Nine Mile Point
Nuclear Station

***Subject: Application for Amendment to the Technical Specifications Concerning
the Safety Limit Minimum Critical Power Ratio – Response to Request
for Additional Information***

Responses to NRC Request for Additional Information (RAI) Documented in NRC Letter Dated January 17, 2002

Figure 1 Cycle 8 Reference Core Loading Pattern

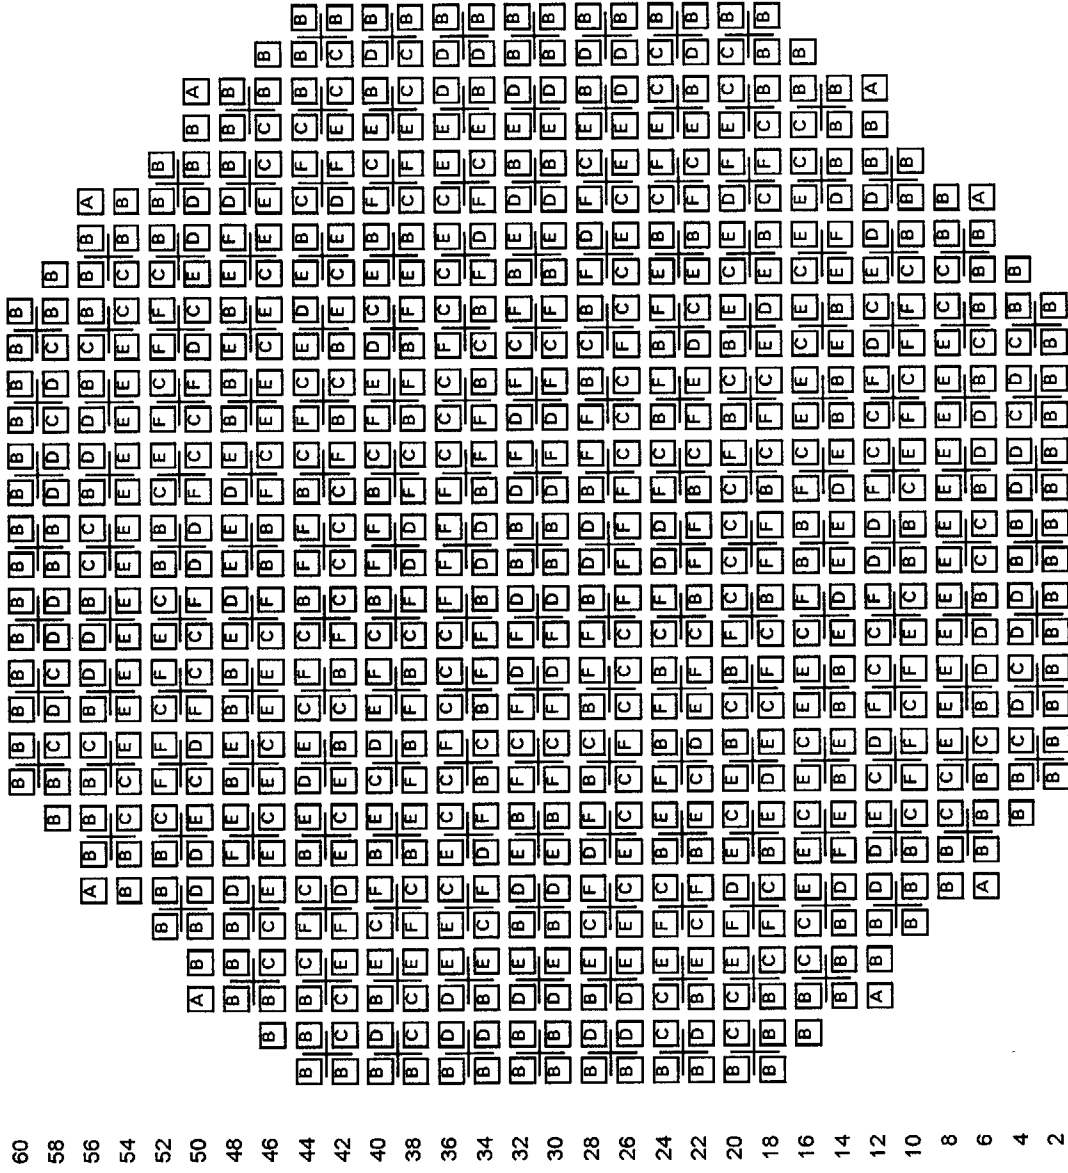
Provide information on the reference core loading pattern for Cycle 8 and Cycle 9, including bundle name, number in core, and identification of cycle loaded.

The reference core loading patterns for Nine Mile Point Unit 2 (NMP2) Cycle 8 and Cycle 9 operation are provided in Figure 1 and Figure 2, respectively. The figures also identify the fuel type, cycle loaded, and number in core for Cycle 8 and Cycle 9.

Fuel Type	Cycle Loaded	No.
A=GE11-P9CUB349-10GZ1-120M-146-T	5	8
B=GE11-P9CUB375-12GZ-120T-146-T	6	236
C=GE11-P9CUB413-12GZ-120T-146-T	7	172
D=GE11-P9CUB414-13GZ-120T-146-T	7	100
E=GE11-P9CUB407-14GZ-120T-146-T-2382	8	132
F=GE11-P9CUB407-14GZ-120T-146-T-2383	8	116

Figure 2 Cycle 9 Reference Core Loading Pattern

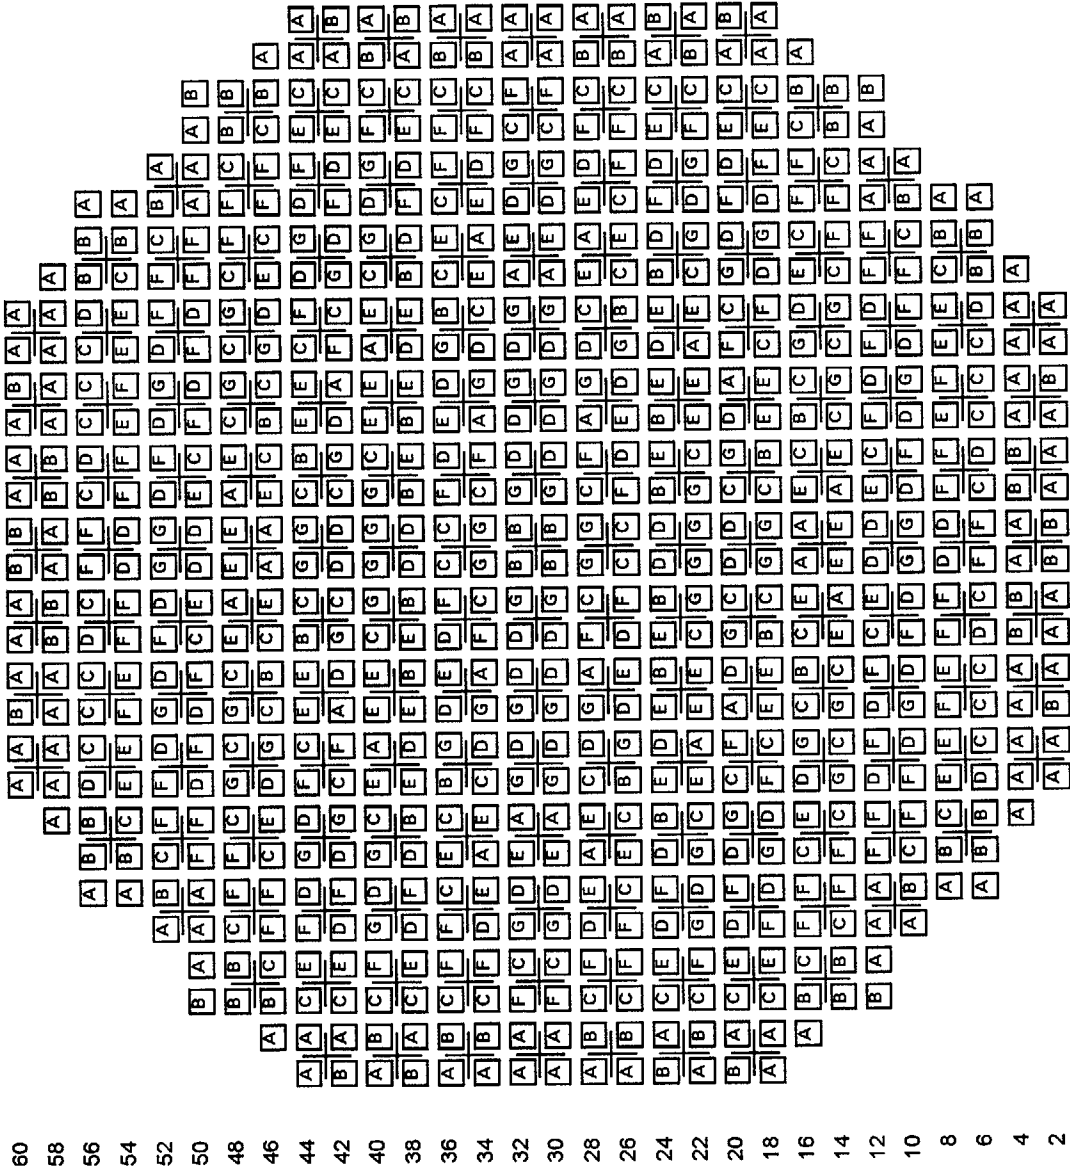
Describe the difference between the reference core loading pattern for the amendment calculation and the real core loading pattern. Also, describe the procedure to deal with the difference if it occurs.

At the current time there are no differences between the reference core loading pattern for Cycle 9 and the planned loading pattern. However, because the reload licensing process requires an assumption as to the condition of the core at the end of the previous cycle, it is possible that the as-loaded Cycle 9 core may not be identical to the reference core.

Fuel Type	Cycle Loaded	No.
A=GE11-P9CUB413-12GZ-120T-146-T	7	136
B=GE11-P9CUB414-13GZ-120T-146-T	7	96
C=GE11-P9CUB407-14GZ-120T-146-T-2382	8	132
D=GE11-P9CUB407-14GZ-120T-146-T-2383	8	116
E=GE11-P9CUB404-12GZ-120T-146-T-2501	9	96
F=GE11-P9CUB407-14GZ-120T-146-T-2502	9	108
G=GE11-P9CUB407-14GZ-120T-146-T-2503	9	80
